UNITED STATES PATENT AND TRADEMARK OFFICE

Office Action Summary

10/501,705

PARK ET AL.

FIG. 3

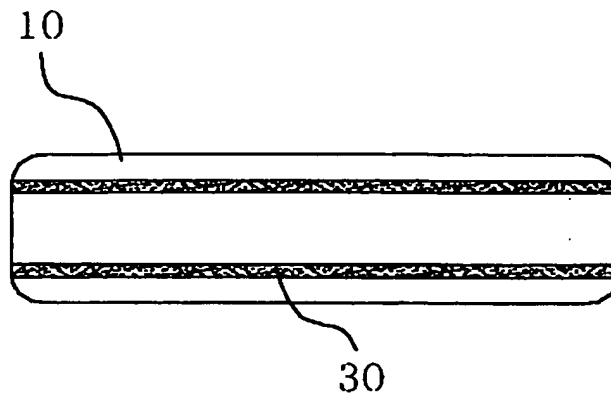
1) The substitute specification filed 7-16-04 has been entered since applicant provided the clean copy, marked up copy and statement of no new matter. In order to expedite prosecution, the drawing sheet containing figures 3 and 4 have been entered since the subject matter of figure 3 is reasonably conveyed by the original disclosure.

FIG. 4

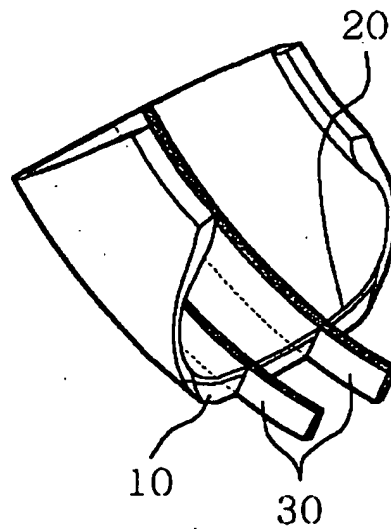
(2) New Figure 4.

New Figure 4 filed 7-16-04 illustrates specific construction of the tire. In particular, new figure 4 illustrates bead regions of the tire and appears to illustrate the electric discharge passages 30 as extending to the inner surface of the tire which defines the inflation chamber of the tire. The above noted subject matter in new figure 4 is not supported by the original disclosure.

Applicant is required to cancel the new matter in the reply to this Office Action.
